**Submission to the Electricity Commission
on the 2008 Grid Planning Assumptions
Consultation: February 2008**

Contact Energy Limited

13 March 2008

Figure 5.7: Typical costs for new electricity generation (updated August 2007)²⁴

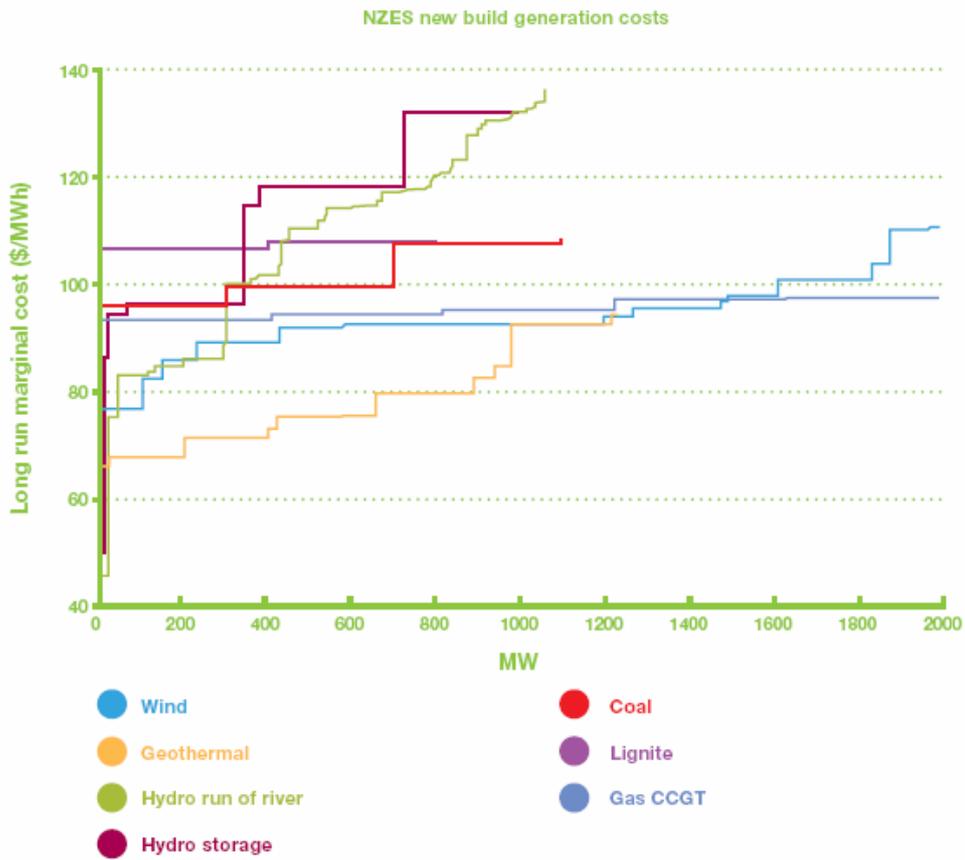
With regard to Table 5 of the consultation document, with its assumed LRMCs for renewable generation sources, we consider that North Island geothermal generation should have a lower LRMC than other renewables and that the megawatt capacity of these lower LRMC geothermals could be somewhat greater than the 250 - 350 MW assumed for Best resources and the ~400 MW assumed in the table for Next resources. For example, Contact alone has 470 MW of new geothermal generation in advanced stages of development¹, so the megawatt capacity levels assumed may be too low.

Further, as can be seen by the following graph (taken from the NZES²), showing LRMCs for new build generation, geothermal has a significantly lower LRMC than other renewables, lower costs for it persist out to approximately 650 MW in capacity, and 1000 MW of the first 1300 MW of new capacity comes from geothermal.
